IE Investigation Report Nos. 50-369/78-20 and 50-370/78-15

Duke Power Company
McGuire Nuclear Plant
Units 1 and 2
Docket Nos. 50-369 and 50-370

Allegation that certain formal written statements made by Duke Power Company to the NRC were incorrect and materially affected the staff's review and acceptance of a revision to the McGuire Final Safety Analysis Report (FSAR).

Sheet No. 7 of 7

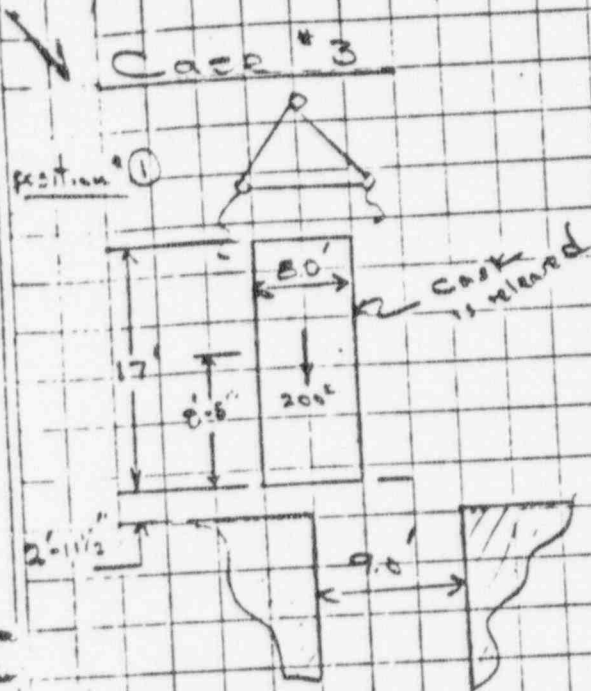
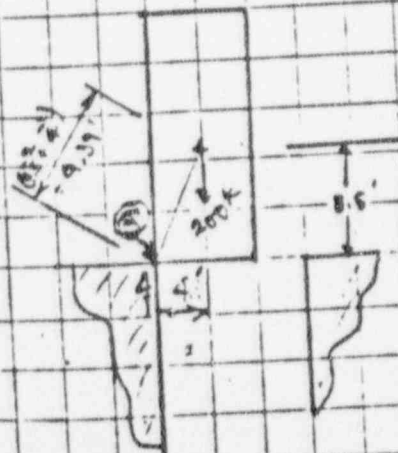
The that assumptions made are too CONSERVATIVE.
CONSIDER THEM below:

A) NO ENERGY LOSS DUE to impact, MATERIAL deformation
OR FRICTION

COMMENT: REINFORCED CONCRETE has the ability to absorb
ENERGY. THEREFORE ENERGY IS LOST @ IMPACT

MATERIAL deformation DOES OCCUR. THE CONCRETE
SPALLS off NEAR the edge and the CASK can be
deformed if dropped.

Dev./Station McGUIRE NUCLEAR STA. Unit 1 & 2 File No. AB12001
 Subject FUEL CASK ACCIDENT By A Date 6/11/7
 Checked By B Date 6/15/7
 Sheet No. 10 of 10

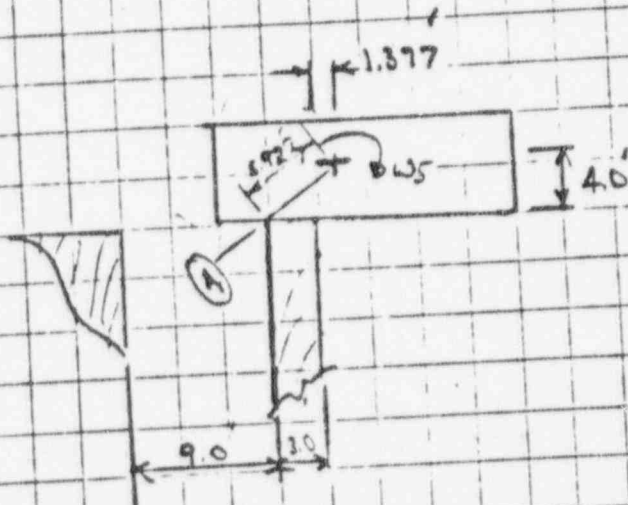
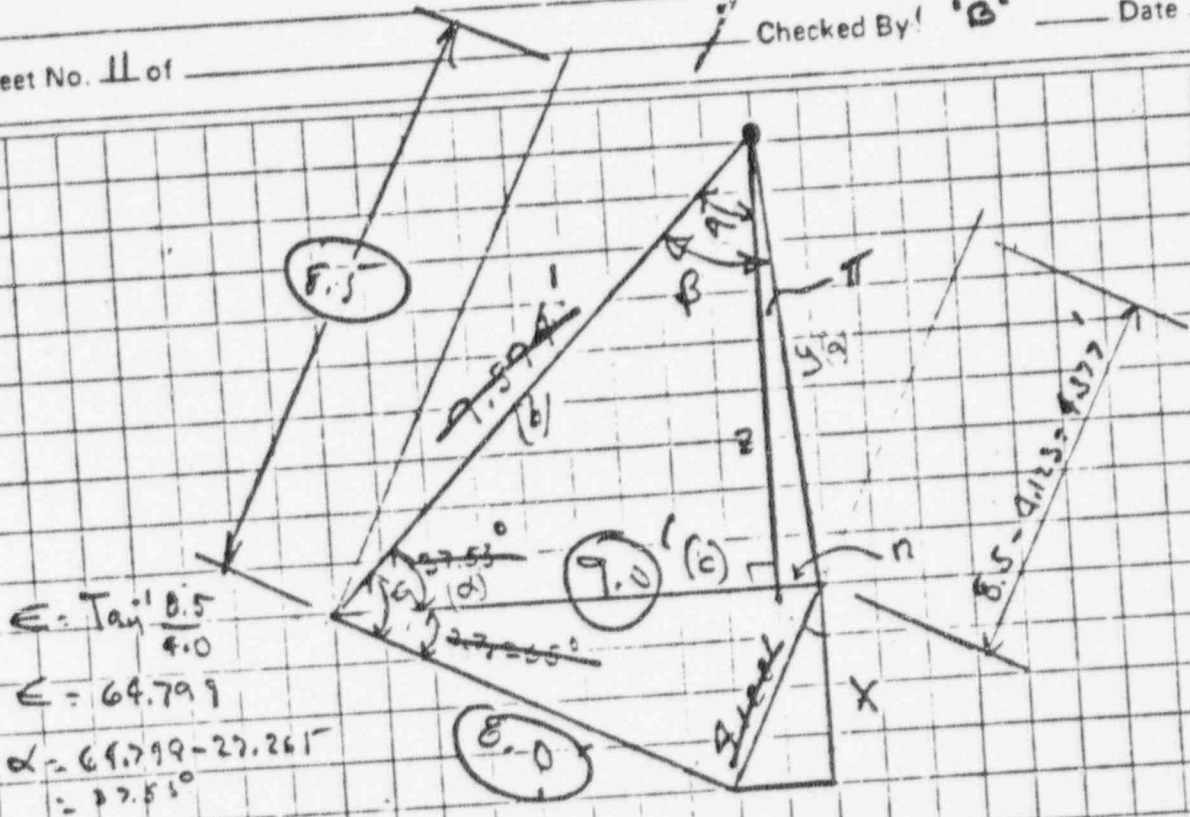
Cask will NOT TOPPLE INTO POOL DUE TO ENERGY LOSS UPON CONTACT WITH CONCRETE, SPALLING ACTION OF CONCRETE & COLLARS & LOCATION OF CENTER OF GRAVITY W/IDE OF CASK AREA before SLIPPING OCCUR. Explained on page 9.

The cask will topple into the spent fuel pool, since the C.G. extends over pool edge & there is rotational energy available before slipping occurs.

CASK DROP EVALUATION
 McGUIRE NUCLEAR STATION
 Figure 9.1.2-1
 (1 of 2)
 Revision E

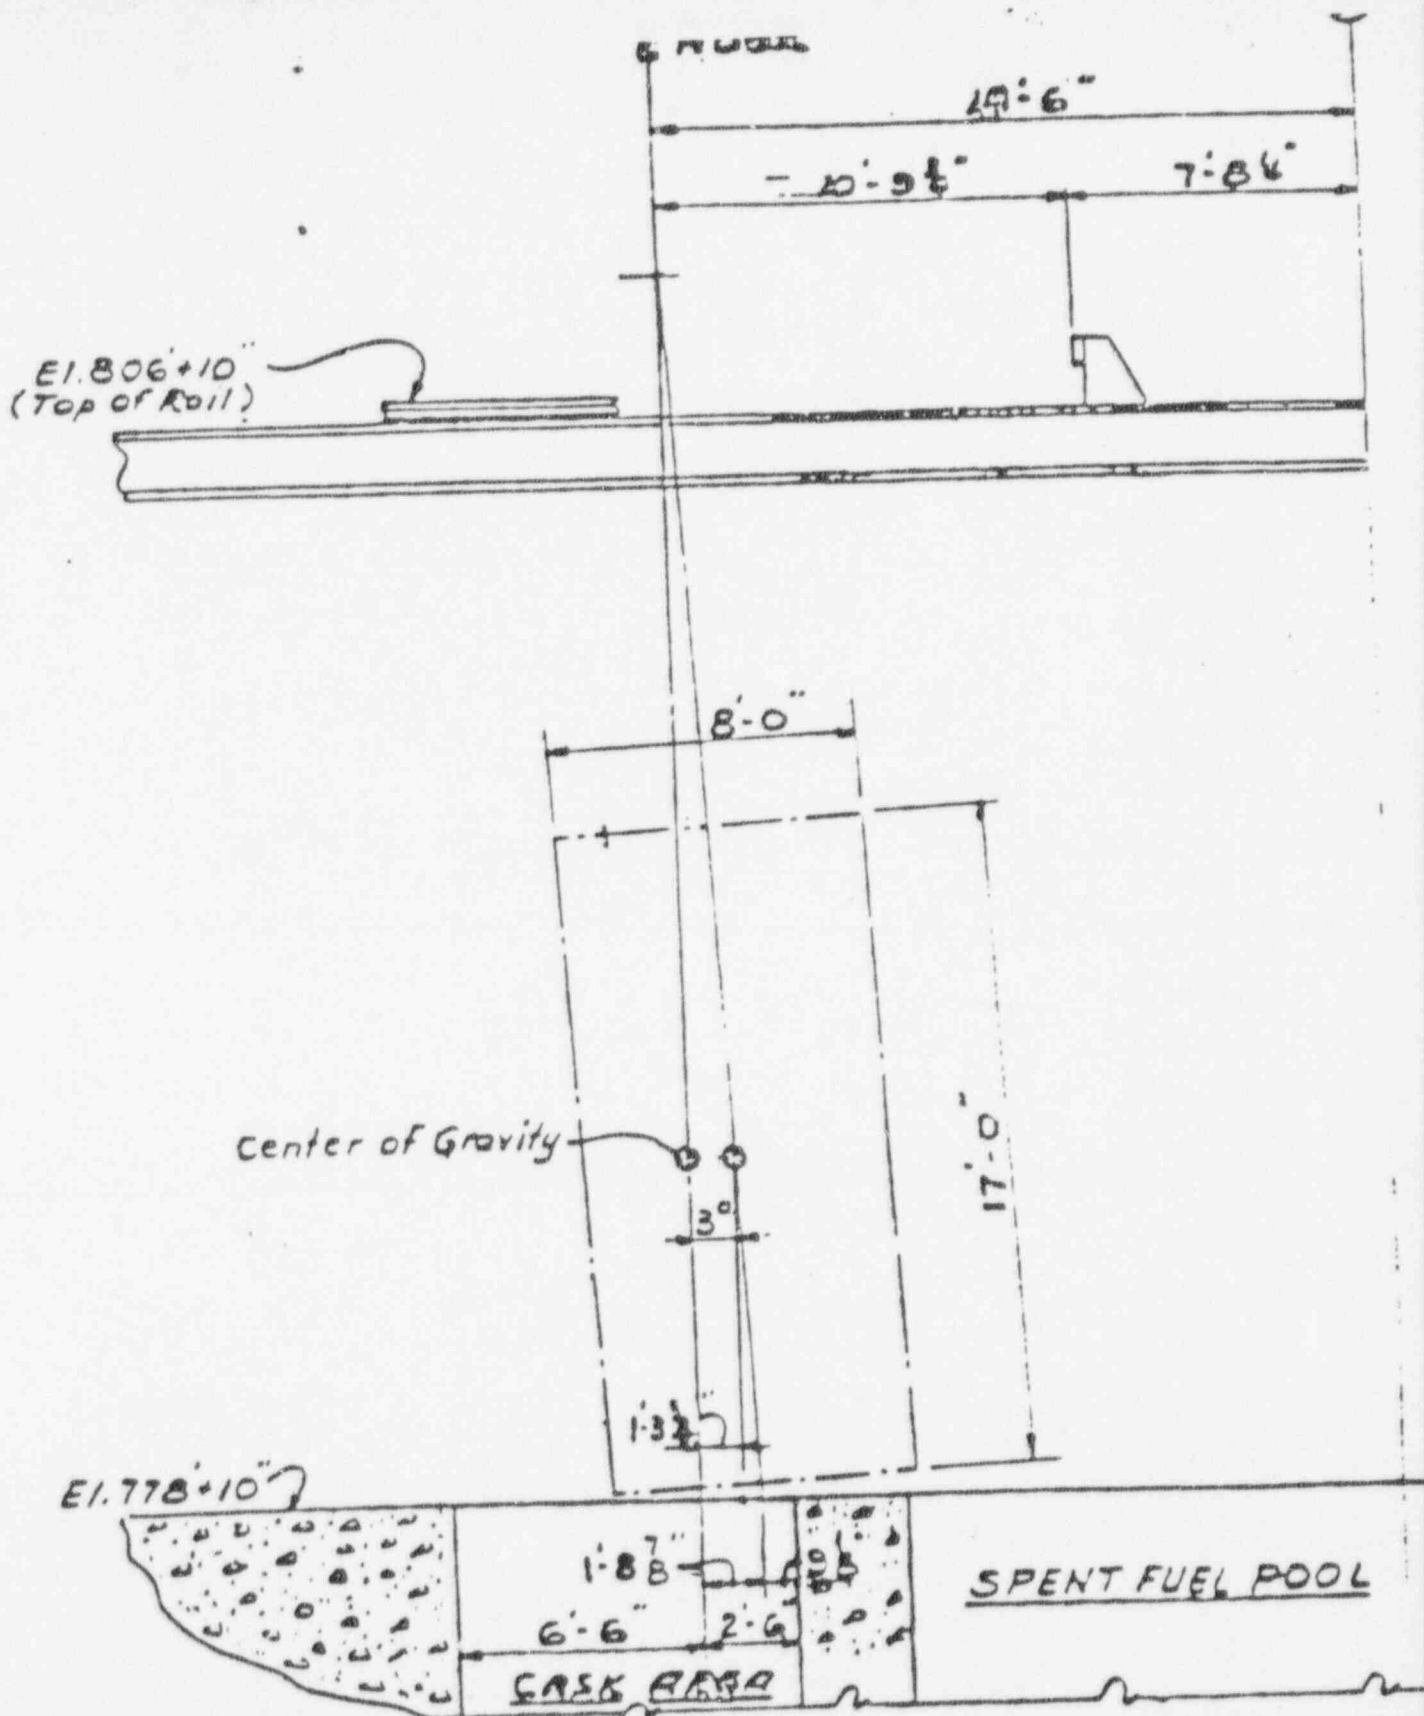
Provide the results of an evaluation to demonstrate that dropping of the spent fuel shipping cask in its vertical or tipped position can not permit the cask to enter the spent fuel storage area or damage safety related equipment.

See revised Subdivision 9.1.2.3.
